RE: Application Cobham House Vineyard 20240544

**Site Address: Cobham House Vineyard, Gold Street, Sole Street,
Kent, DA12 3AA**

**LANDSCAPE & VISUAL REVIEW
VOLUME 1: REPORT**

Project Reference	24290
Status	Final
Issue / Revision	3
Date	02-12-2024
Prepared by	IM
Checked By	CSR

Figure 19 from the GLPCS (with site and associated green infrastructure added)

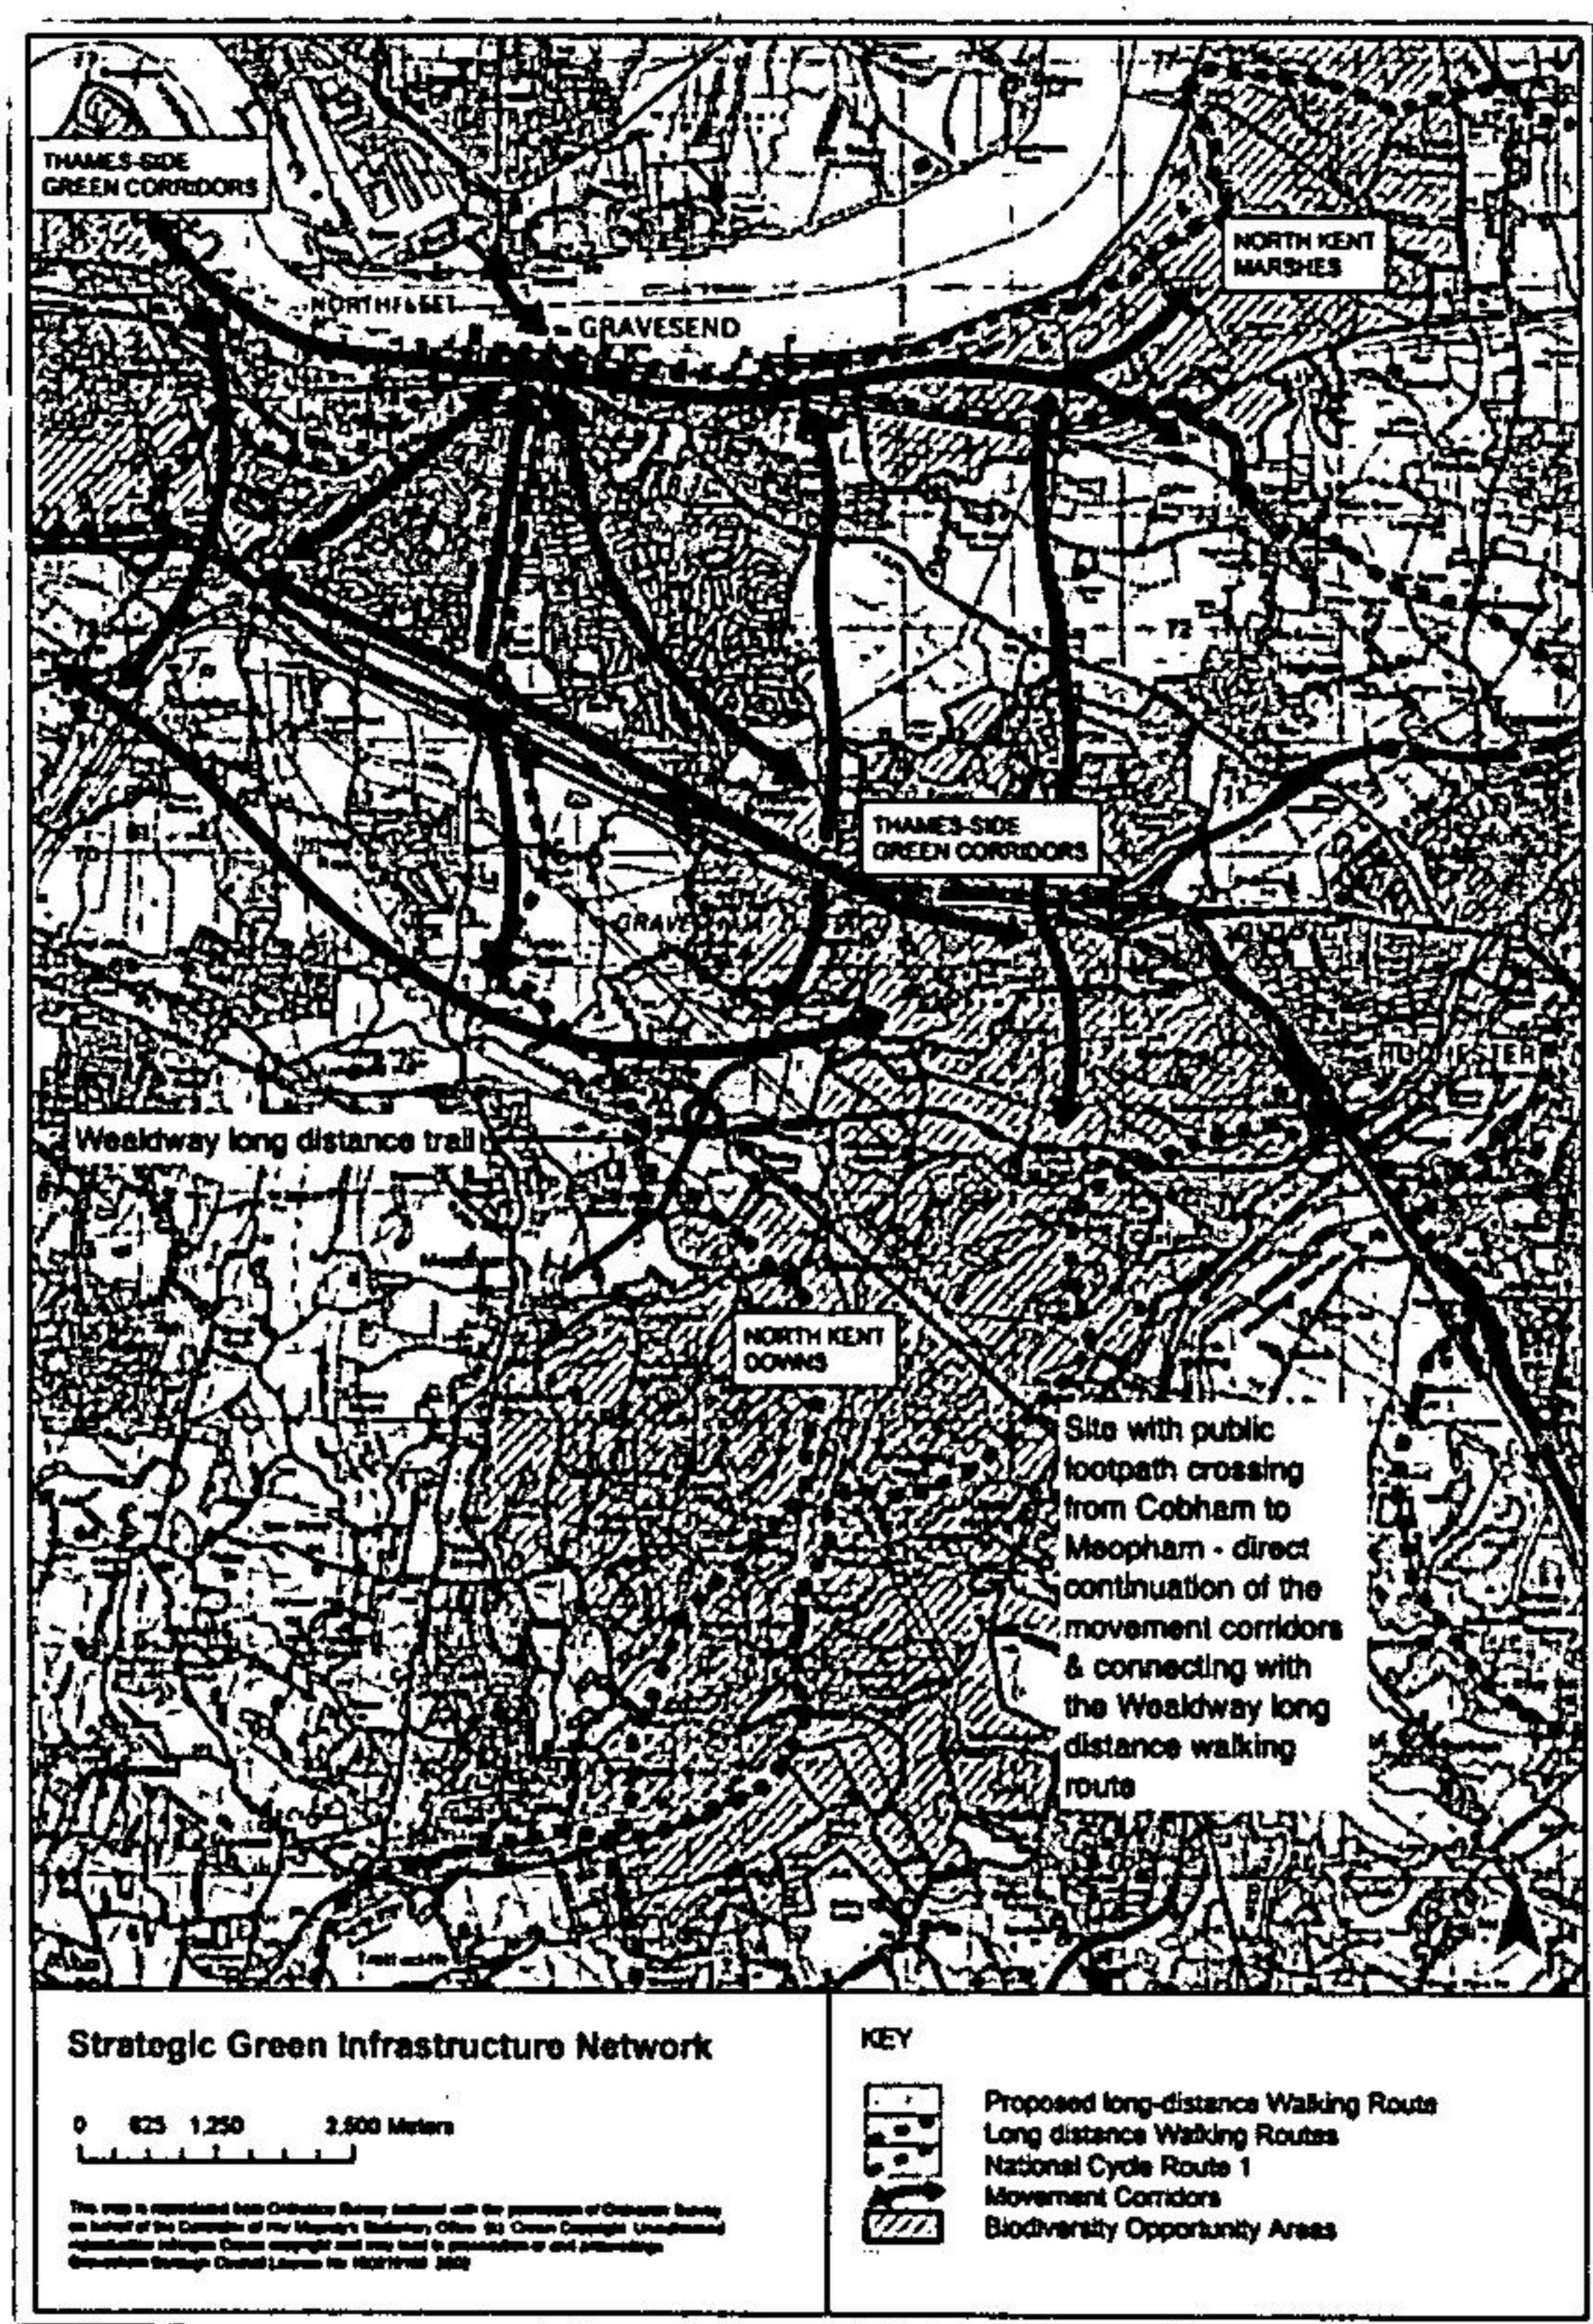
- 11.1.4 The public footpath crossing the site is a key component of the green infrastructure improving access from the urban to the rural area, especially so as it connects with an extensive public footpath network south of the site including a key long distance trail, the Wealdway.
- 11.1.5 Although additional hedgerow and tree and shrub belt mitigation is proposed and beneficial to the restoration and strengthening of key landscape elements, i.e., the western boundary hedge and the irregular northern boundary of the field. The tree belt to the south of the proposed winery is disconnected from the existing boundaries and is effectively 'floating' within the field, both visually and from a biodiversity perspective, lacking beneficial connectivity to existing and proposed hedgerow habitats.
